**Committee of Experts on the Transport of Dangerous Goods  
and on the Globally Harmonized System of Classification  
and Labelling of Chemicals****Sub-Committee of Experts on the Transport  
of Dangerous Goods****Fortieth session**

**Updating of the Globally Harmonized System of  
Classification and Labelling of Chemicals (GHS):  
physical hazards****Amendments to the classification flow chart/decision logic for  
self-reactive substances and organic peroxides****Transmitted by the International Council of Chemical Associations  
(ICCA)<sup>1</sup>****I. Introduction**

**Figure 2.4.1: Flow chart scheme for self-reactive substances**  
**Figure 2.5.1: Flow chart scheme for organic peroxides**

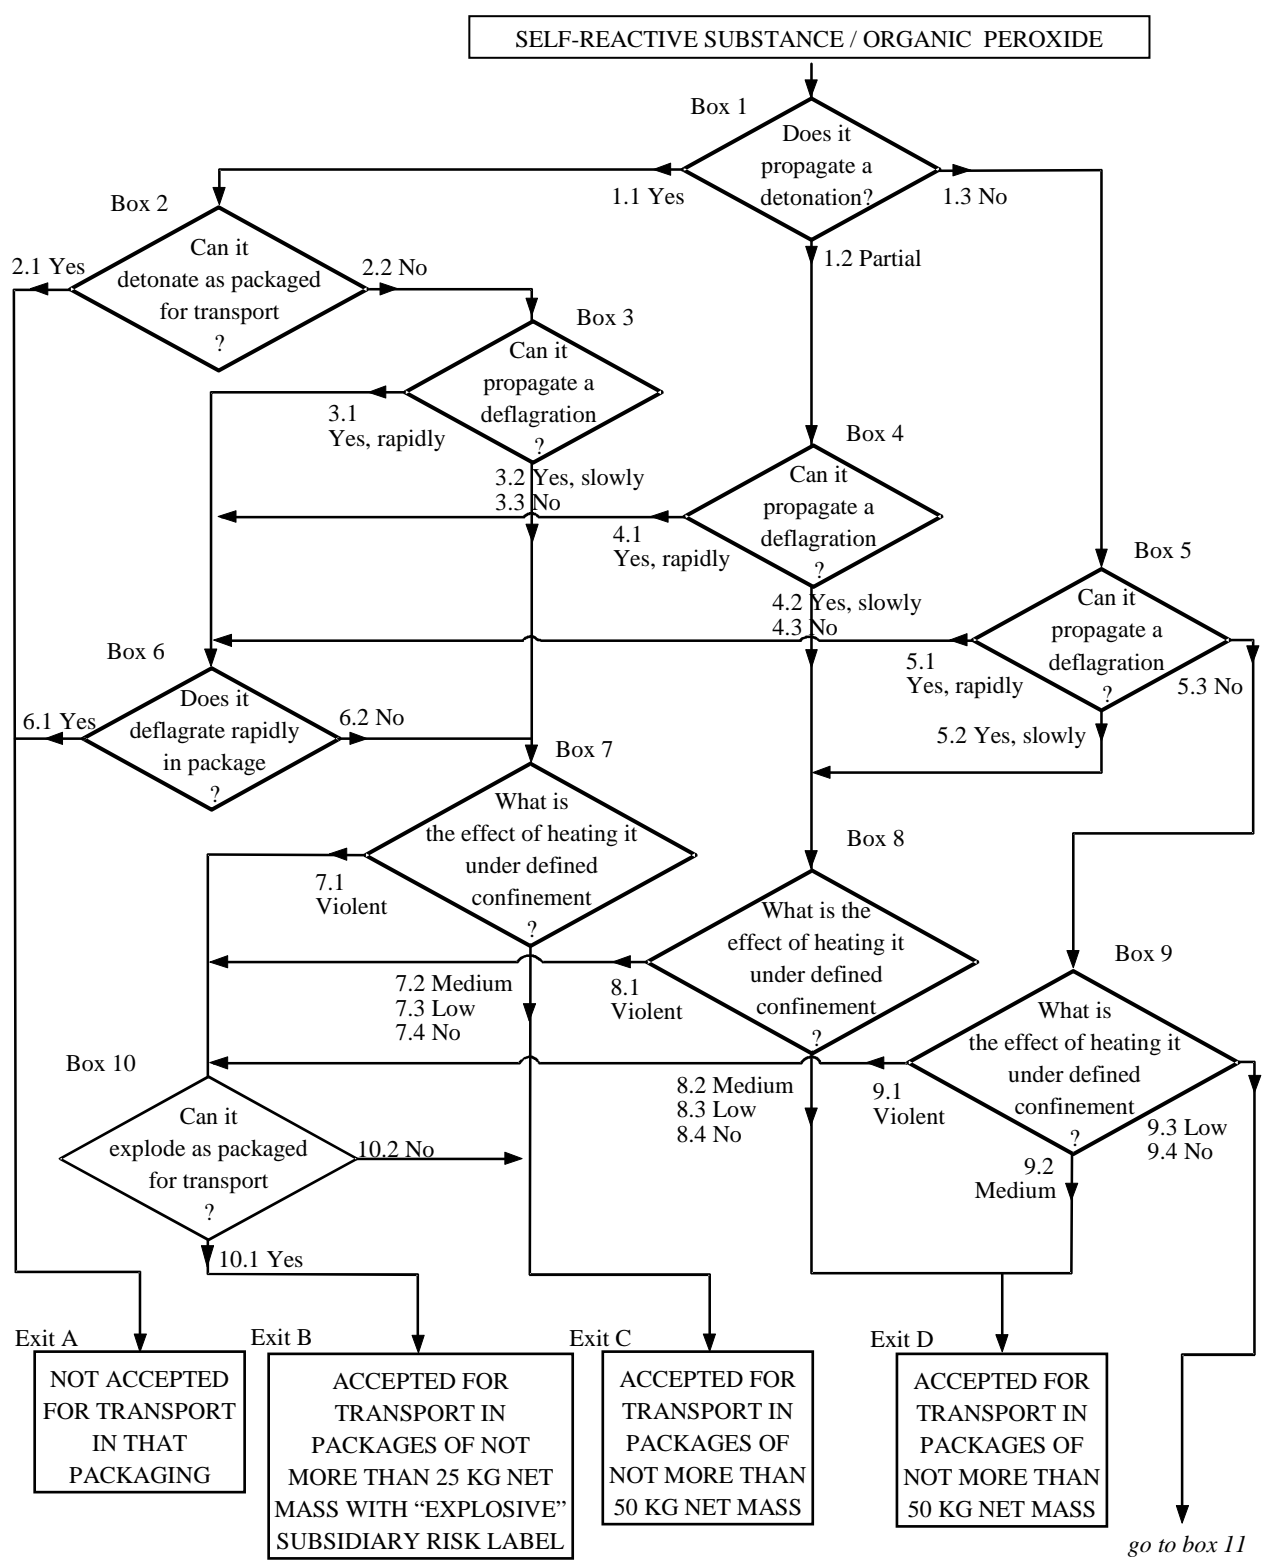
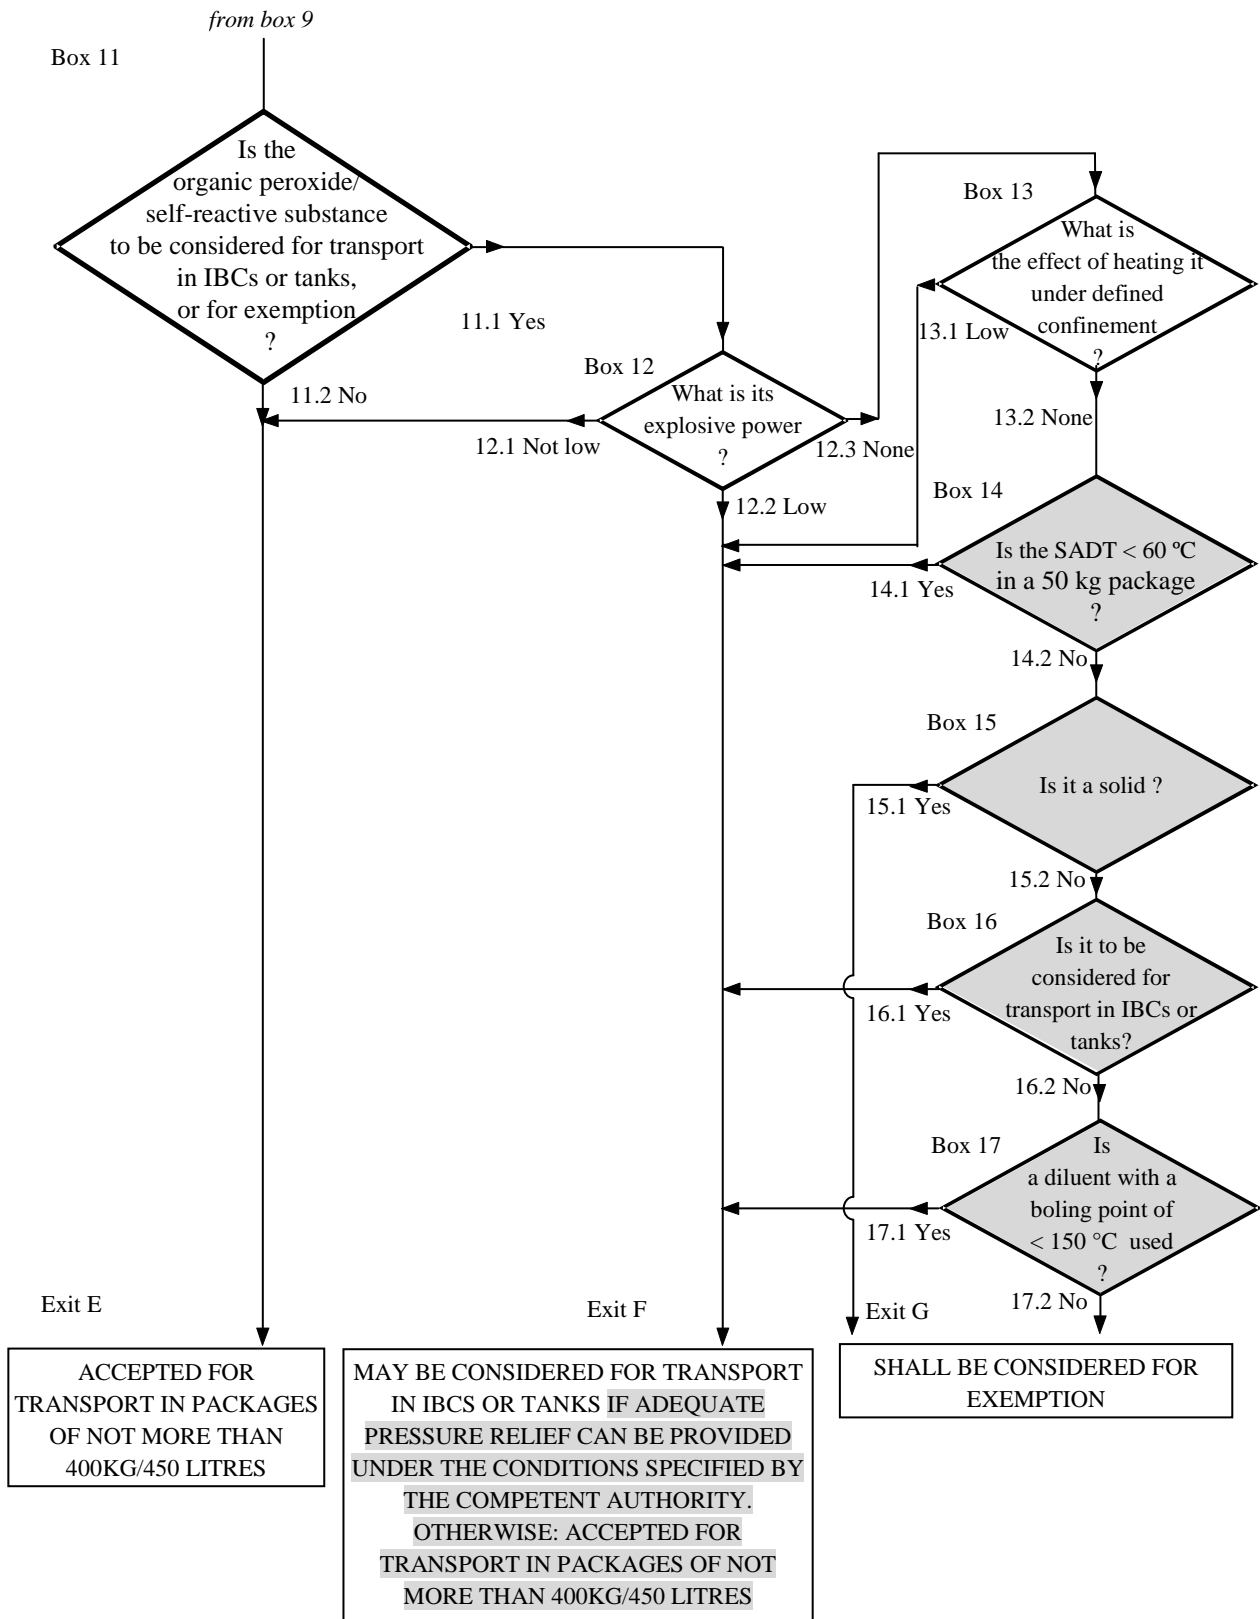
8. In the proposed amended flow chart these two aspects are addressed in the new boxes 15 and 16 and the wording in exit F (in flow chart Model Regulations).

9. Based on the background given in sub-sections 2.1 (no change in classification principles) and 2.2 (change in classification principles for Type G substances) the following is proposed (changes in grey shading):

(a) In the Model Regulations replace Figures 2.4.1 and 2.5.1 by the following new scheme:

10. Based on the background given in sub-section 2.1 (no change in classification principles), it is proposed to take proposal alternative 1 with the deletion of boxes 15 and 16 and deleting the grey shaded wording in exit F of the proposed flow chart scheme in paragraph 9 (a) (i.e. proposal for the Model Regulations).

**Decision logic 2.8 for self-reactive substances and mixtures**  
**Decision logic 2.15 for organic peroxides**

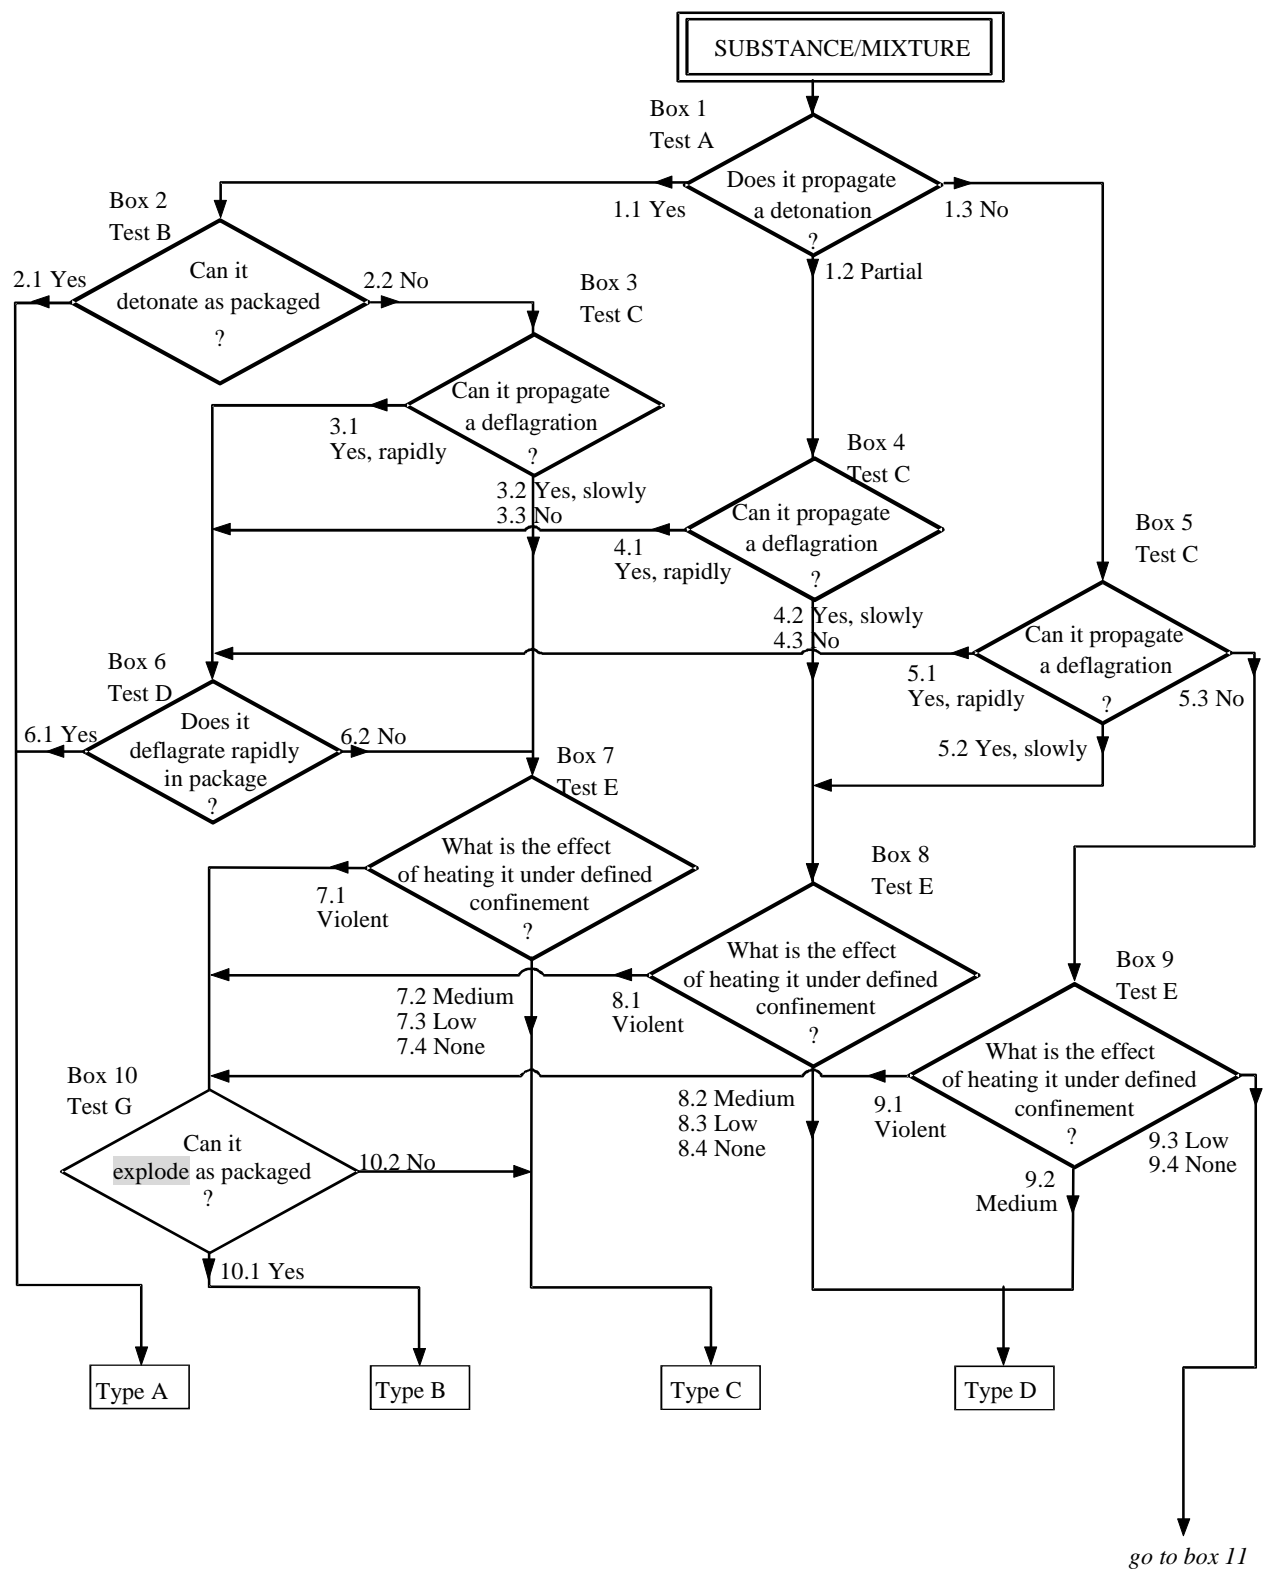
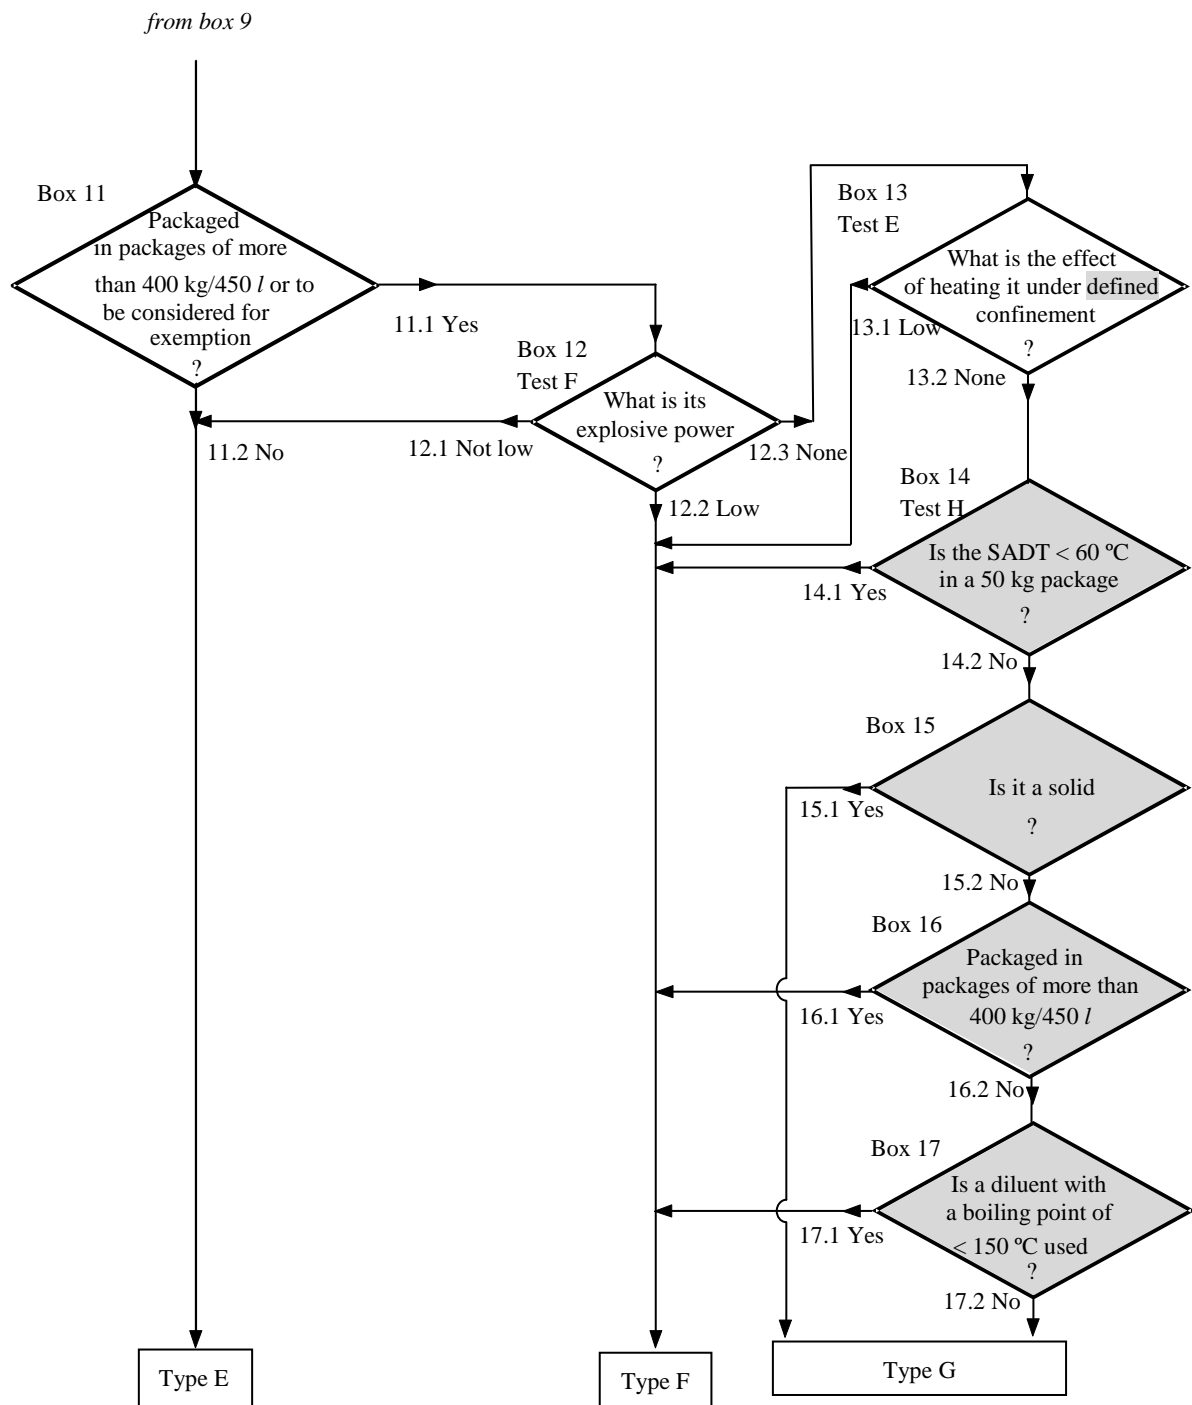
(b) In GHS replace Figures 2.8 and 2.15 by the following new decision logic:

(Note: the grey shaded wording in boxes 10 and 13 are just corrections.)
